Re: Nine Mile Point Unit 1  
AEC Docket No. 50-220

Nine Mile Point Unit 1

Proposed Changes to Technical Specifications

FIGURE 3.1.7.a MAXIMUM ALLOWABLE AVERAGE PLANAR LHGR  
APPLICABLE TO FUEL TYPE INITIAL CORE

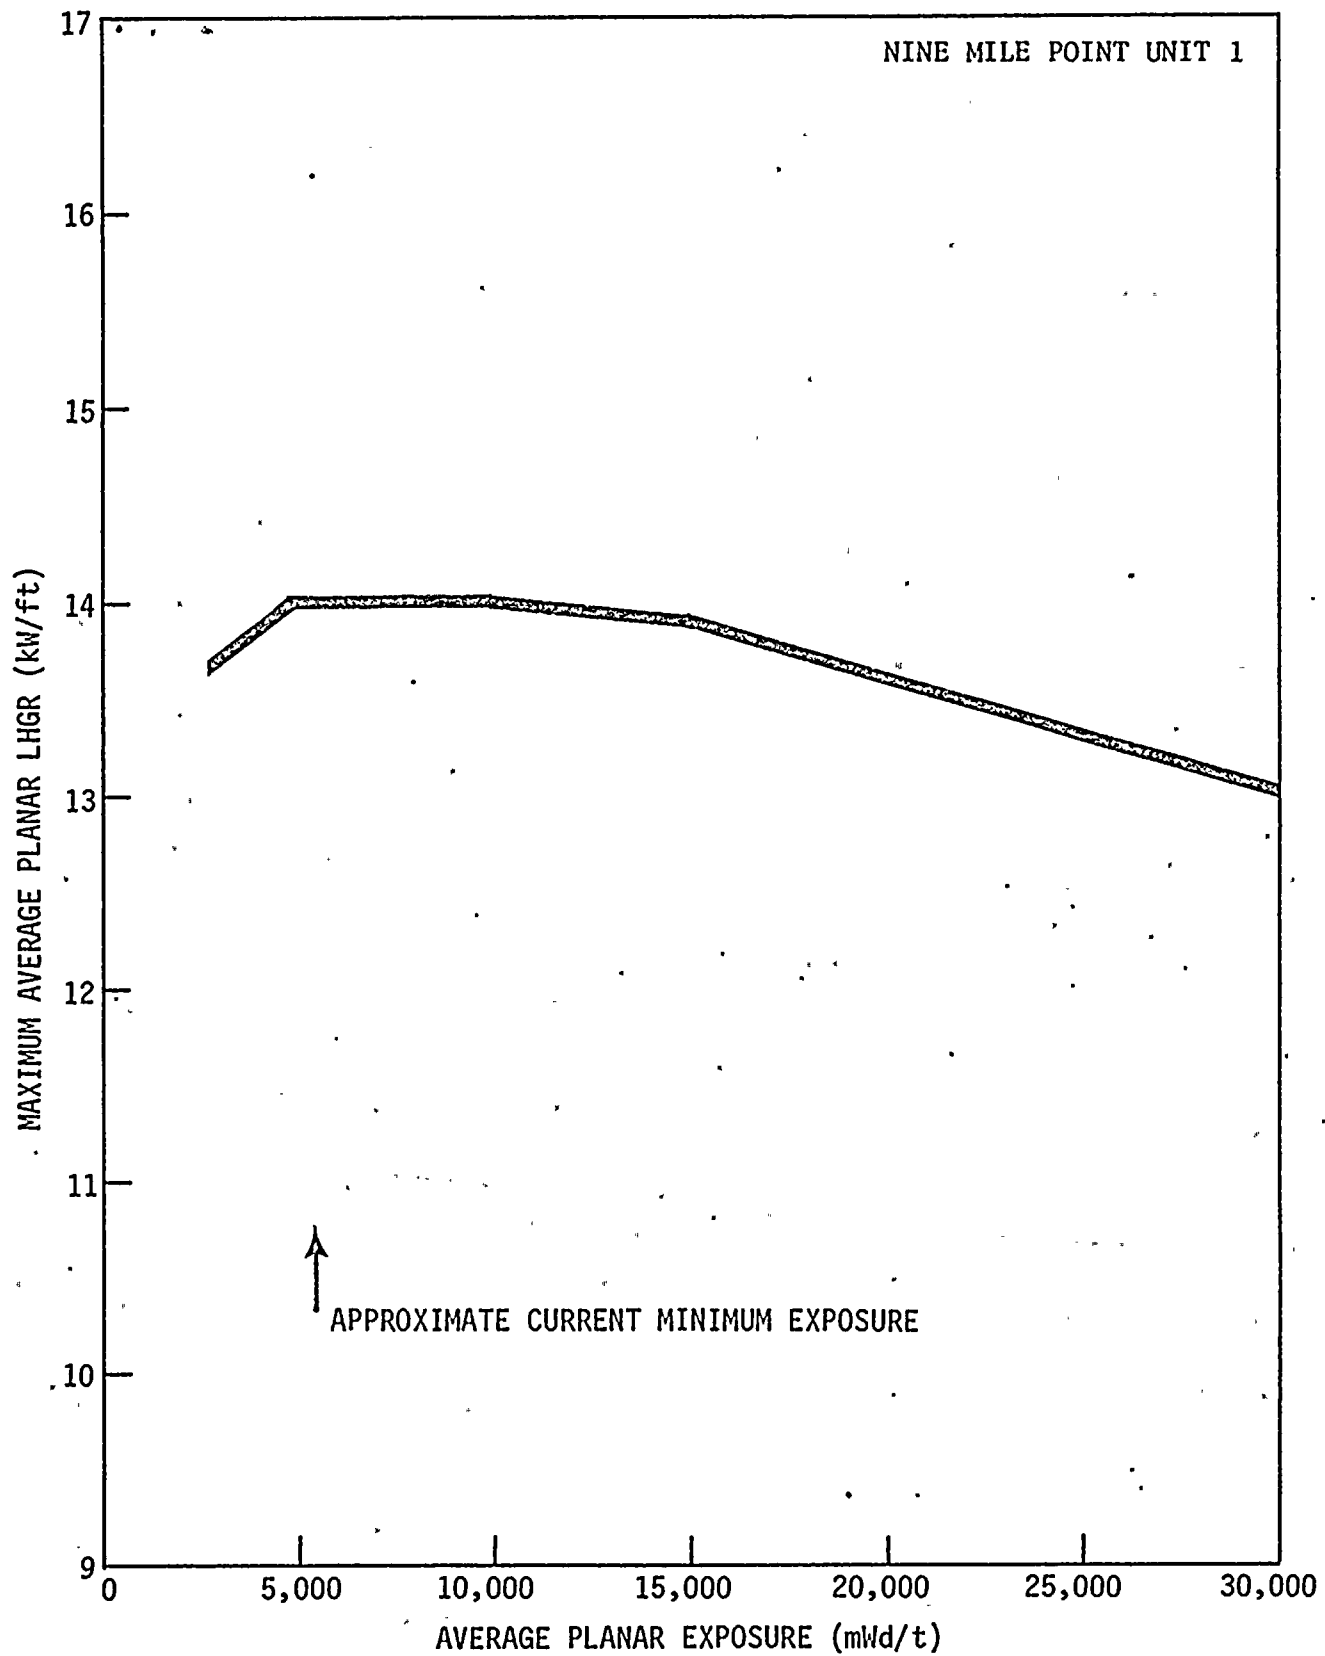
Delete Figure 3.1.7 and replace with the attached Figures 3.1.7a, b, c and d. Under the Limiting Condition for Operation 3.1.7, delete the phrase in the last sentence in paragraph a. of the Specification "Figure 3.1.7" and replace with the phrase Figures 3.1.7a, b, c and d.

Replace the third through sixth paragraphs of the Bases 3.1.7a with the following: "The maximum average planar LHGR curves for the various fuel types in the core shown in Figures 3.1.7a, b, c and d are based on calculations using the models described in the GE reports NEDO-10735, as modified by the GE reports NEDO-20181 and the GE letter of December 12, 1973, to V. Moore from J. Hinds, 'Plant Evaluation with GEGAP-III.'"

Changes to the maximum average planar LHGR are warranted based on results of further analysis and model development as related to the effects of fuel densification. This additional information is described in GE reports NEDO-20181.
